ABERDEEN CITY COUNCIL

COMMITTEE	Operational Delivery Committee
DATE	13 January 2021
EXEMPT	No
CONFIDENTIAL	No
REPORT TITLE	Driveway Appeal
REPORT NUMBER	OPE/20/245
DIRECTOR	Rob Polkinghorne
CHIEF OFFICER	Mark Reilly
REPORT AUTHOR	Jack Penman
TERMS OF REFERENCE	1.1.1

- 1.1 To consider an appeal on behalf of the owner of 108 Corrennie Circle, Dyce, against the decision by the Council as Roads Authority to refuse permission for the creation of an additional footway crossing to serve a new driveway.

Appendix 2

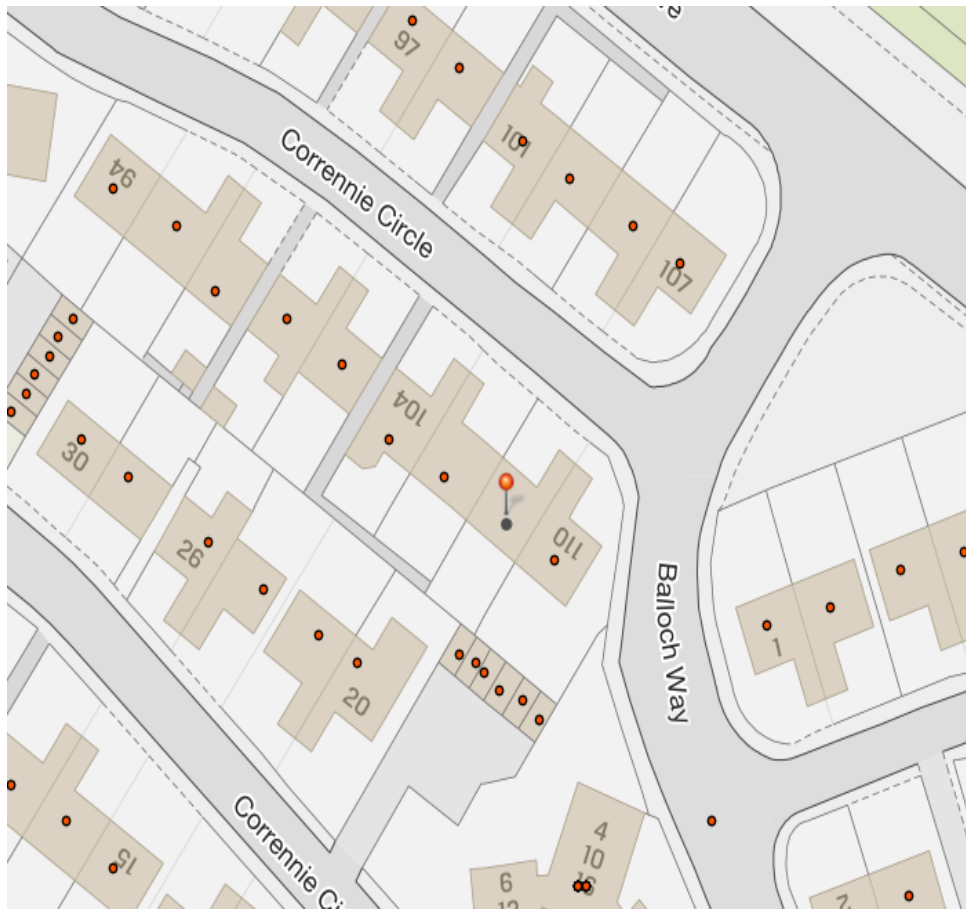
It is noted from the images and plan supplied there is an existing crossing point to a garage and separately a newly constructed driveway. The aforementioned condition does not apply at this location where the frontage is ~ 8m and therefore two crossing points would not be permitted.

Additionally, it is noted the new driveway appears to also be lacking a drainage channel which unless modified would mean it was not suitable under the regulations.

An alternative to a new crossing point would be to extend the existing access to the maximum permitted 5 dropped kerbs. I however note that there is a lighting column which would prevent this being possible.

I therefore cannot grant permission for a new crossing or extension at this location
